CONSTRUCTION PLANS FOR CREEKSIDE AT LORSON RANCH FILING NO. 1 STREET AND STORM SEWER CONSTRUCTION PLANS

Engineering Review

PUDSP-18-005
SF-19-00X

**CREEKSIDE AT LORSON RANCH FIL NO. 1
STREET / STORM SEWER
CONSTRUCTION PLANS**

DATE: APRIL 15, 2019
 PROJECT NO. 100.045
 SHEET NUMBER **C9.7**
 TOTAL SHEETS: 34

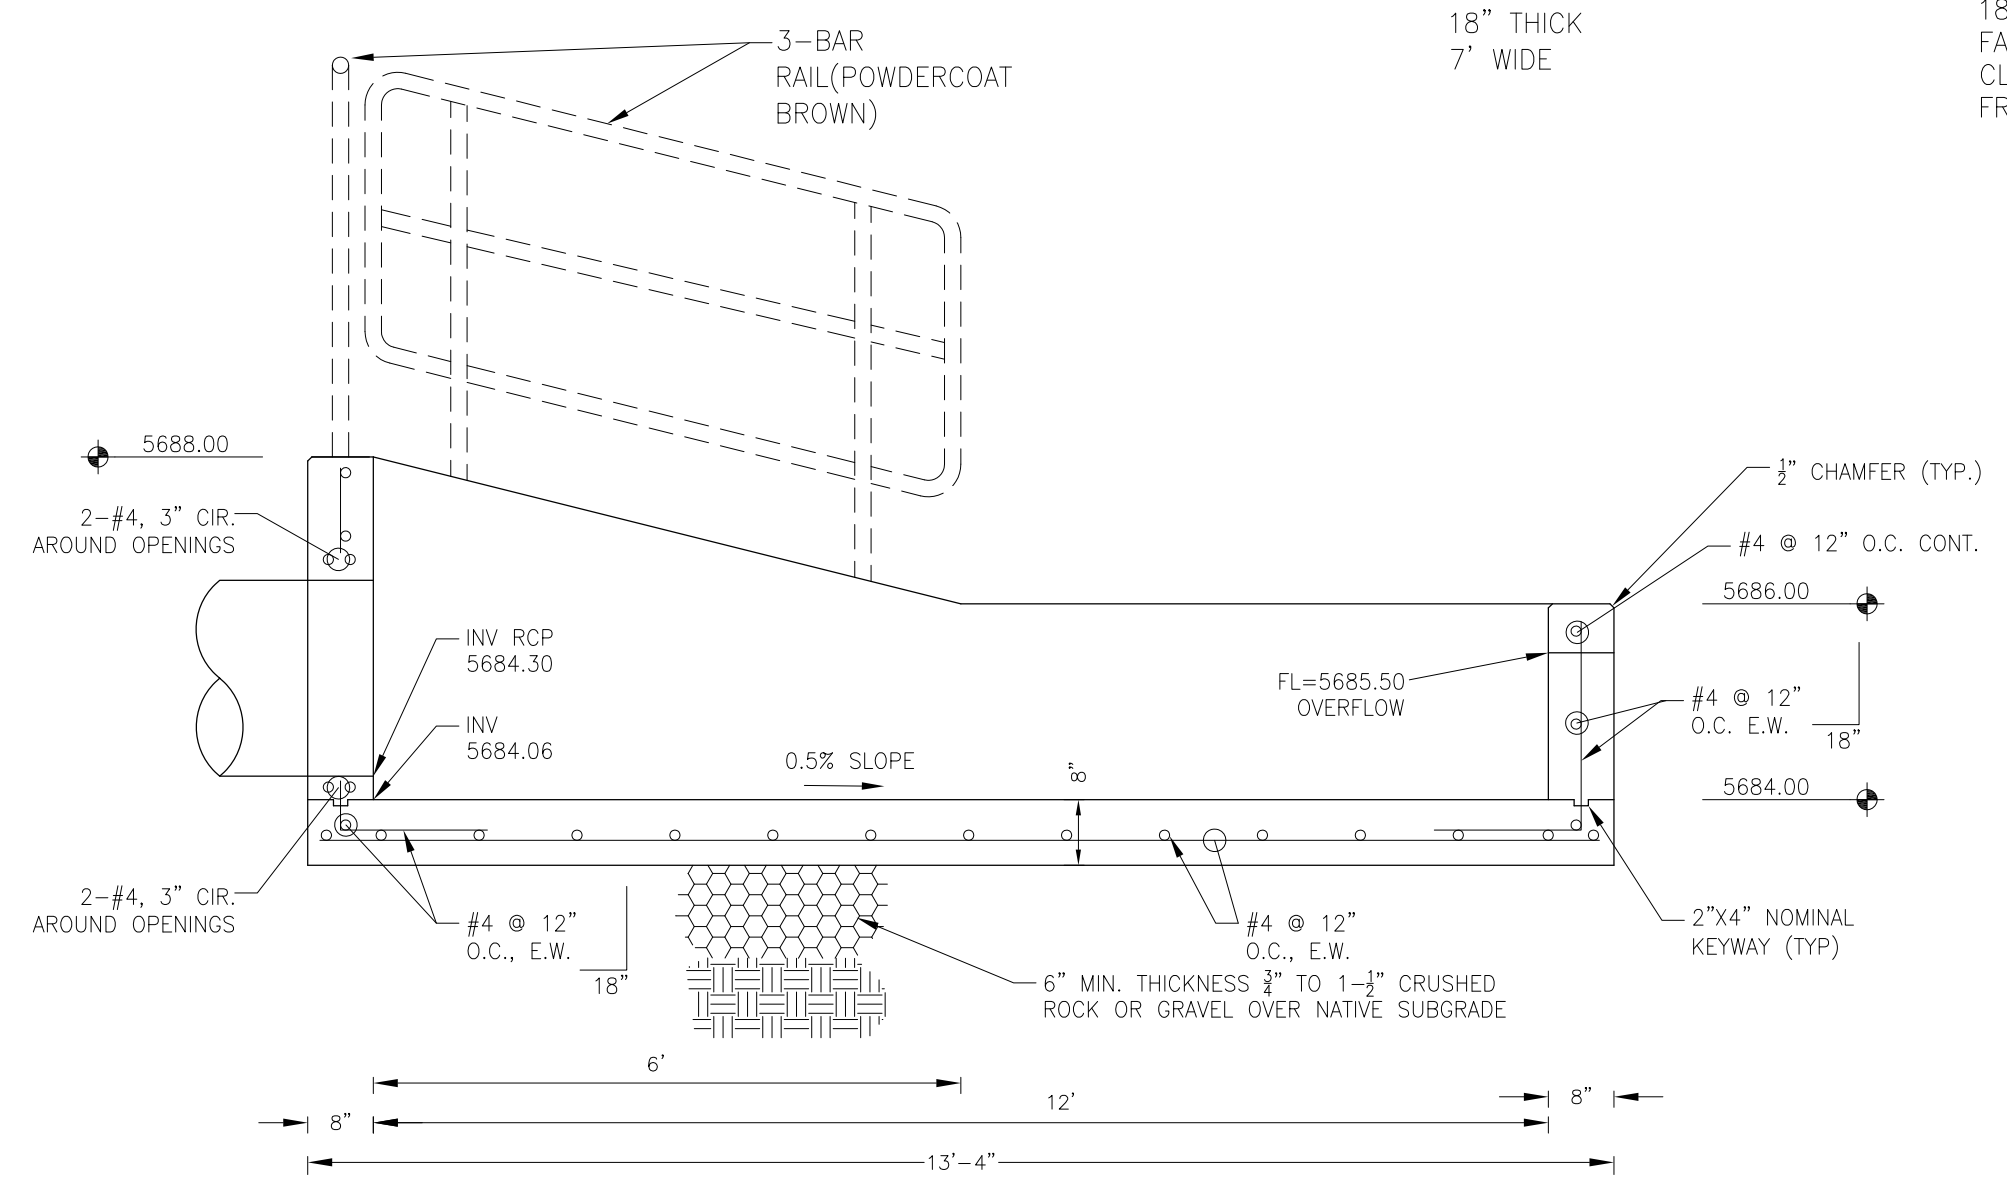
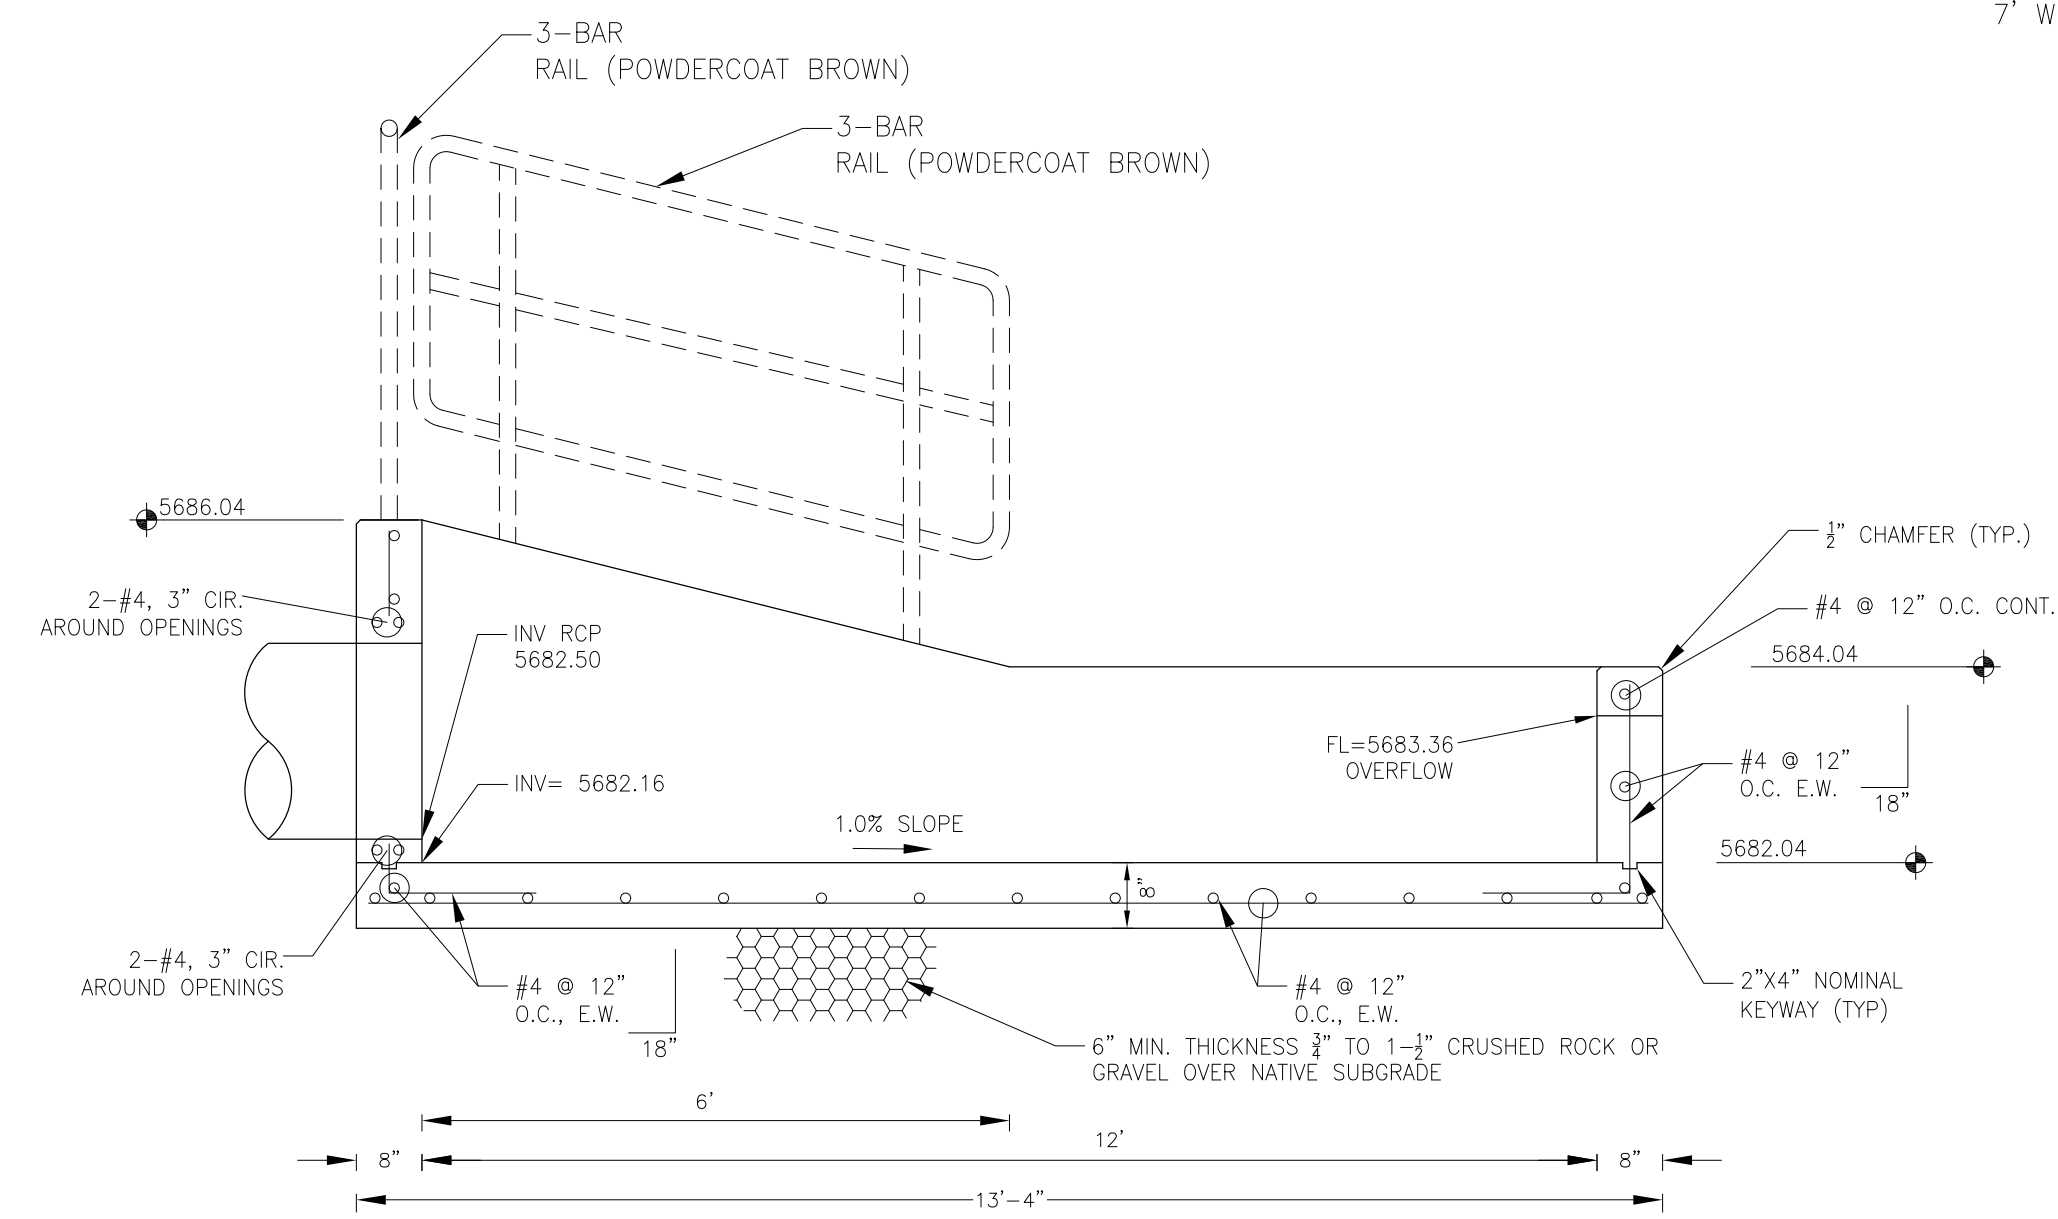
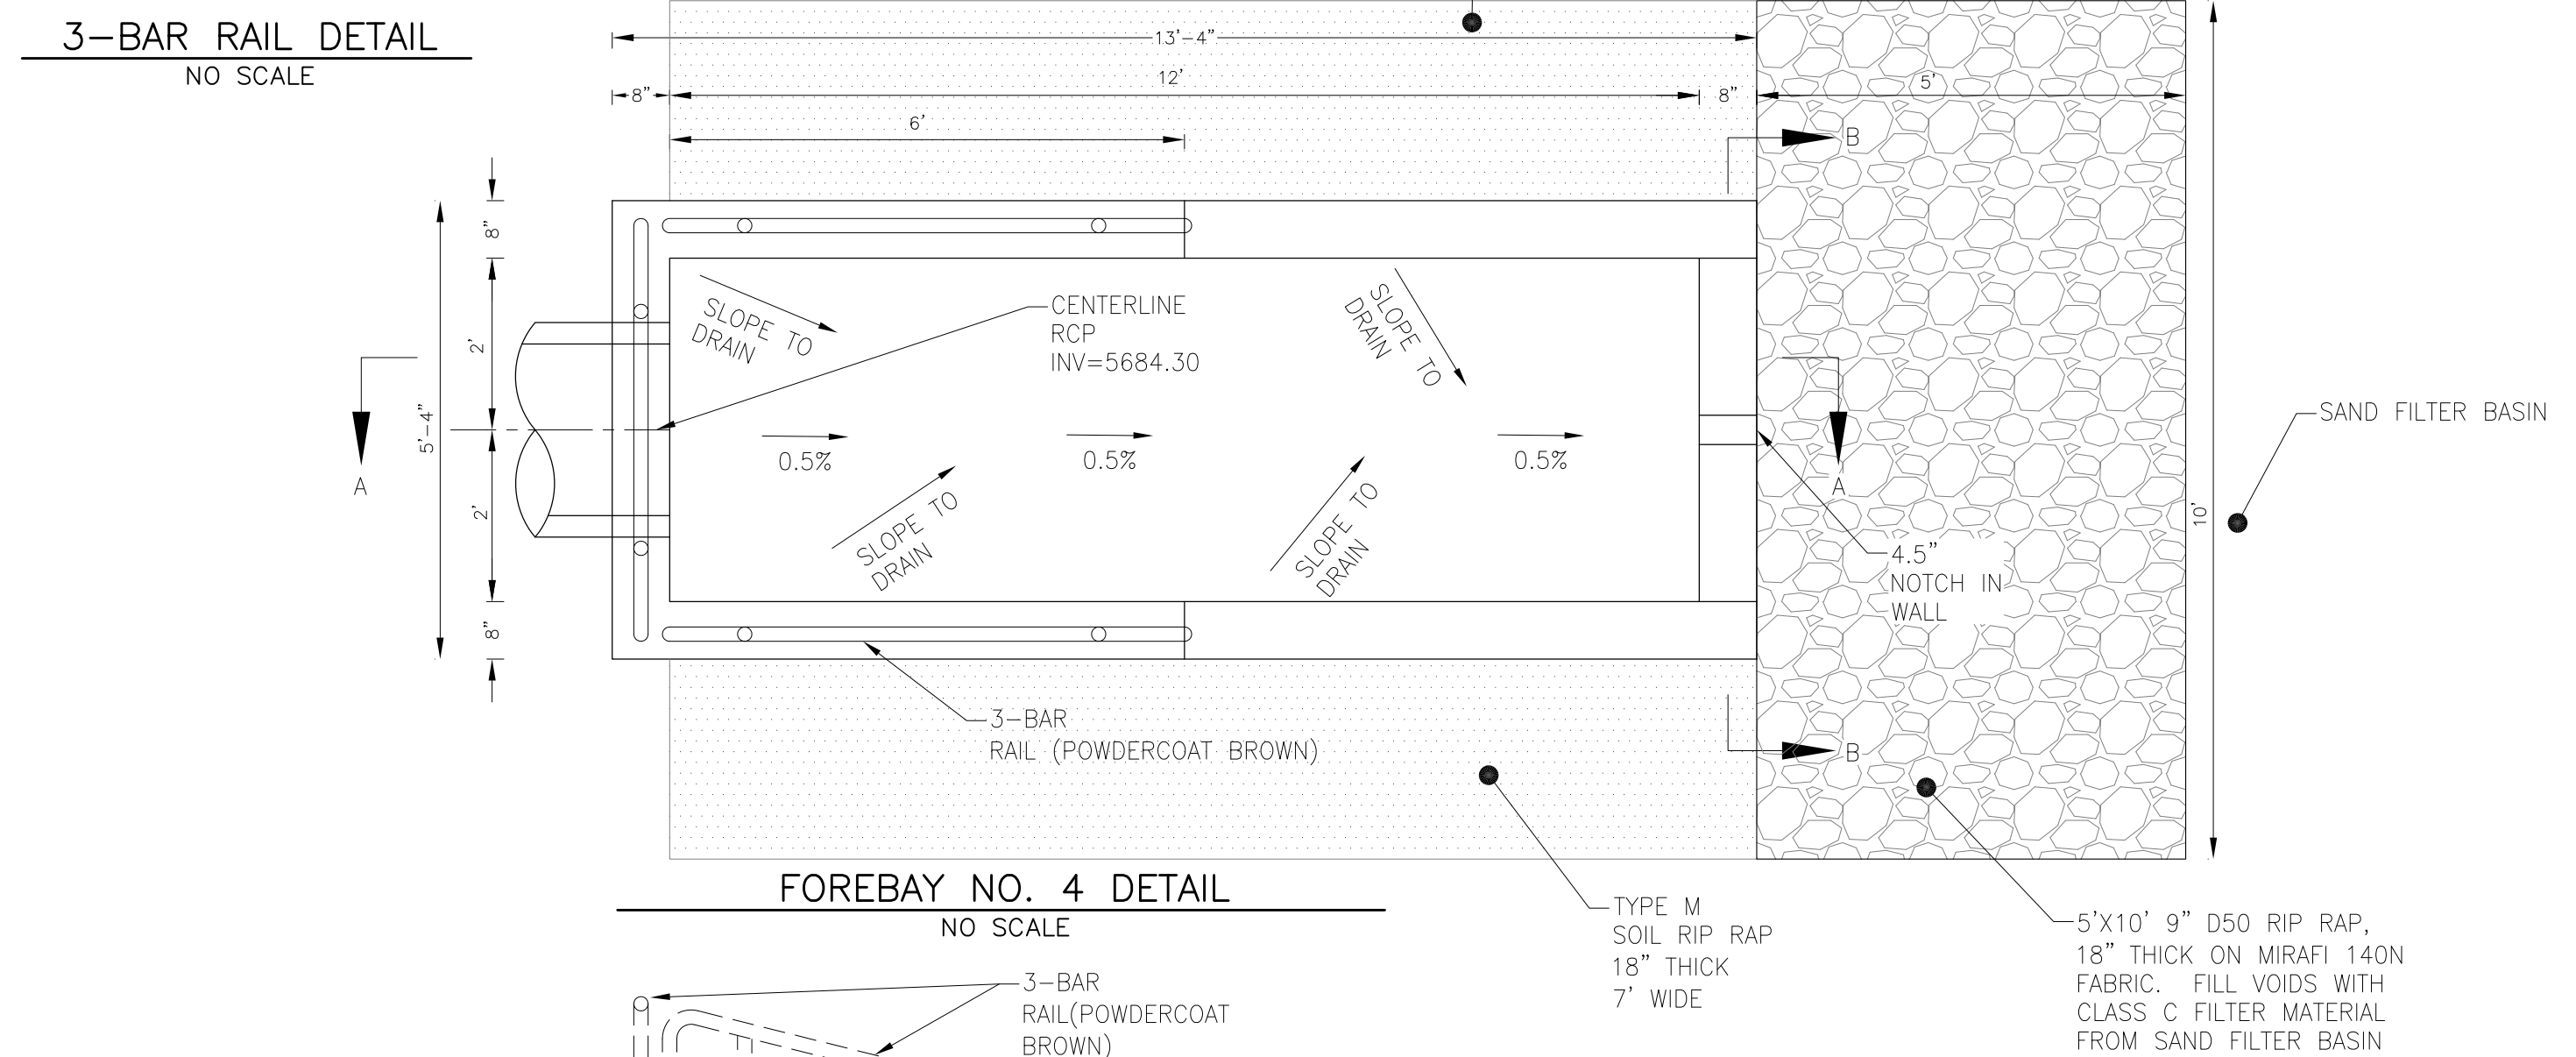
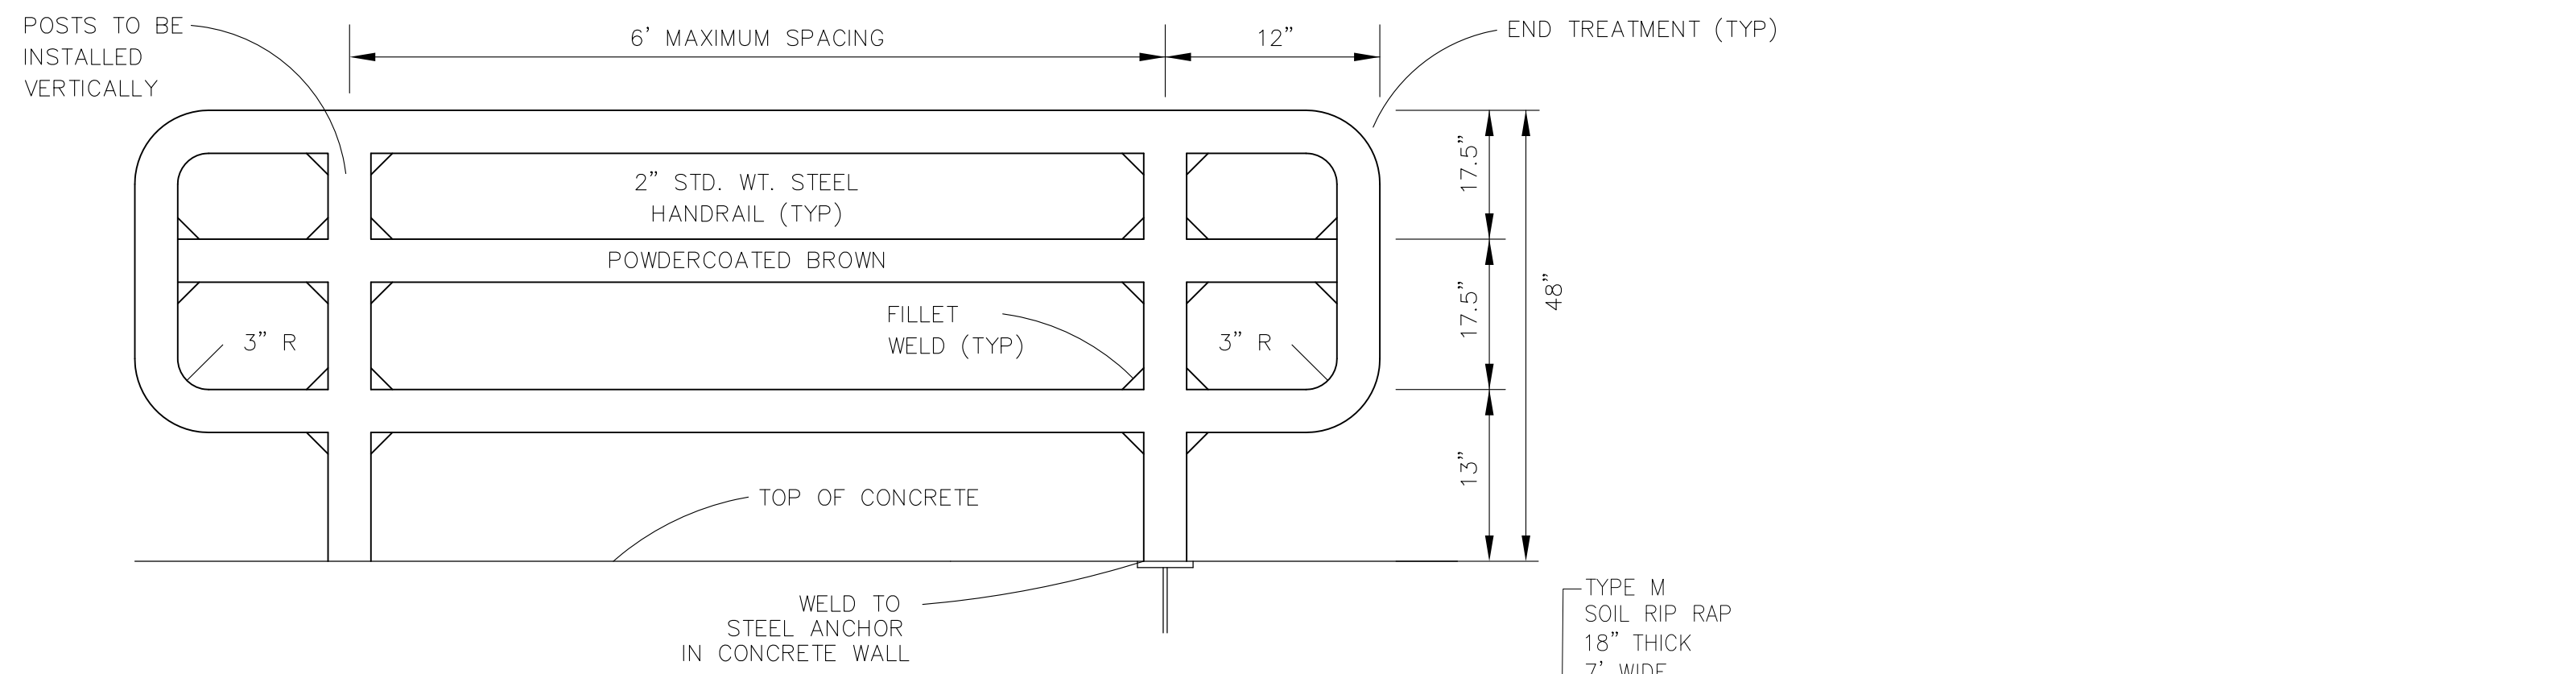
Isn't 2A the reverse/reflection of 2B?
